# PREDETERMINATION SETTLEMENT AGREEMENT

CP# 12-17-71358  
HUD# 07-18-8267-8

Confluence consists of one building located at 103 SW 3<sup>rd</sup> Street.<sup>2</sup> The residential building and common areas will all be required to meet the same accessibility requirements of the ICRA and FHA. The building was issued a Certificate of Occupancy, signed by Cody Christensen, Building Official for the City of Des Moines, on March 30, 2017.

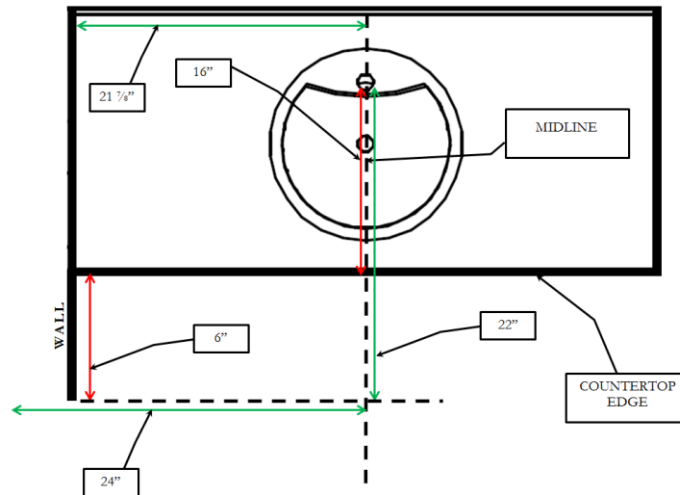
8) The midlines of the bathroom sinks at all inspected units were measured by ICRC Investigators at no less than 24” away from the closest wall, which complies with the 24”-inch minimum required. Although the Tester reported the midlines of the sink to be 21 7/8” away from the wall – as claimed in the second allegation from the current complaint – this distance was measured by the Tester to a wall that extends 6” horizontally from the countertop edge in front of the sink, as measured during the inspection. ICRC Investigators measured the distance from the faucet spouts and control handle to the counter top edge at 16” and the height to the top of the sink rims to be no more than 33”. In order for someone in a wheelchair to make a centered parallel approach to the bathroom sink such that the wall adjacent to the sink is no longer an obstruction and achieve the 24”-minimum to the adjacent wall, the wheelchair user need be 22” away from the faucet spout and control handle. As reported on page 17 of the current report, ANSI 1986 allows a 24”-maximum horizontal reach distance over an obstruction if that obstruction has a 34”-maximum height. Therefore, a centered-parallel approach that is in compliance with the 24”-minimum distance from the closest obstruction to the midline of the bathroom sink is possible if the wheelchair user is no less than 22” away from the faucet spout and control handle. Please see the illustration below for a representation of the above description:

Although the distance that the Tester measured from the midline of the bathroom sink to wall was initially determined to be representative of the actual distance to the closest obstruction, the analysis of the information collected during the inspection by ICRC Investigators did not support the initial determination. Therefore, no evidence was found to support the allegation that the midline of the bathroom sink is closer to the nearest obstruction by less than the 24”-minimum required.

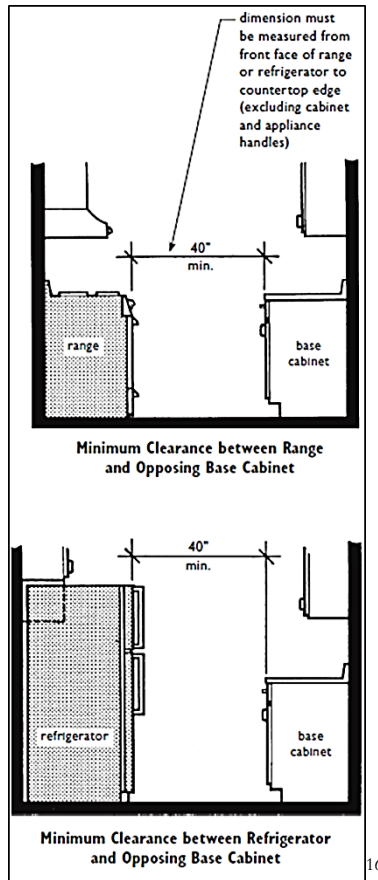
(a) The parties agree the width of the path between the kitchen island and the opposing refrigerator is 38 3/4" in Unit 405 [1BR-B], which is less than the 40-inch minimum width required by the Manual.

(b) Respondents agree to increase the clear width of the path between the kitchen island and opposing features to no less than 40 inches in Unit 405 by reinstalling the countertop on the kitchen island further away from the opposing features to meet the 40-inch minimum distance, as required in the Manual. Respondents agree to measure the clear width of the path as indicated in the figure at the top of the next page:
